Ref: 191251_Let8_Rev5 18 November 2021

Re: Yennora Liquid Waste Treatment Plant (SSD-10407) - Outstanding Information

This letter contains additional information requested in Yennora Liquid Waste Facility - SSD 10407 – based on consultation with DPIE in September, October, and November 2021.

Figure 1: Proposed Equipment Plan

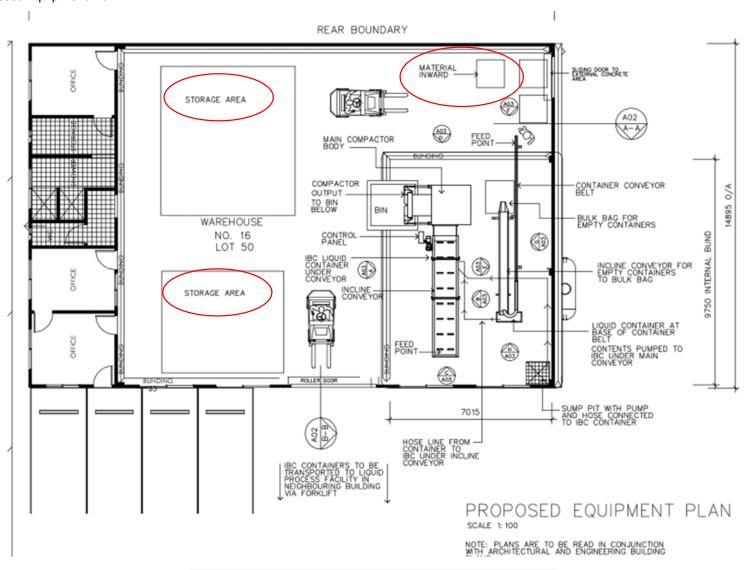
• Show on a plan where pallets of out-of-date liquid product/food waste are received

This is shown in the proposed equipment plan, IBCs are taken off trucks via forklift and placed within the storage areas shown or where "material inward" is marked on the plan, for direct processing.

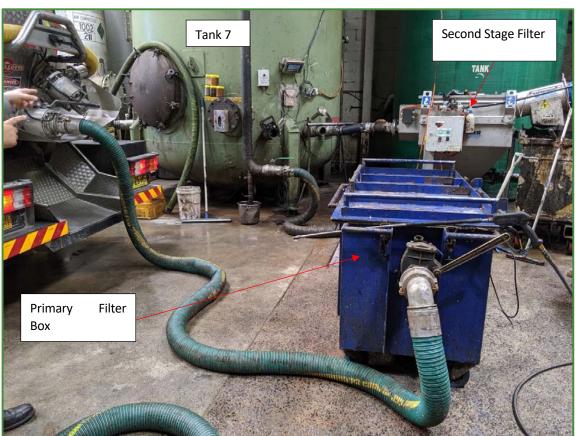
• Confirm that liquid waste is pumped directly from the tanker into a storage tank via a filter on receival and provide more information about the filter (point 3 of section 5.5)

Confirmed: Liquid waste is pumped directly from the tanker into a storage tank via a filter. The filter is a box filter which removes residual solids.

An image of the filters is provided below. The hose from the tanker truck connects to one side of the filter. The liquid passes through a screen which collects the solids. The other side of the filter box is connected to the receival tank, which tank depends on the waste stream involved (see process flow diagram – detailed process flow diagrams provided with the EIS are presented as high resolution on two separate pages for 14 and 16 Kiora Crescent in Attachment 6 to this letter). The solids are shovelled out into a bin.
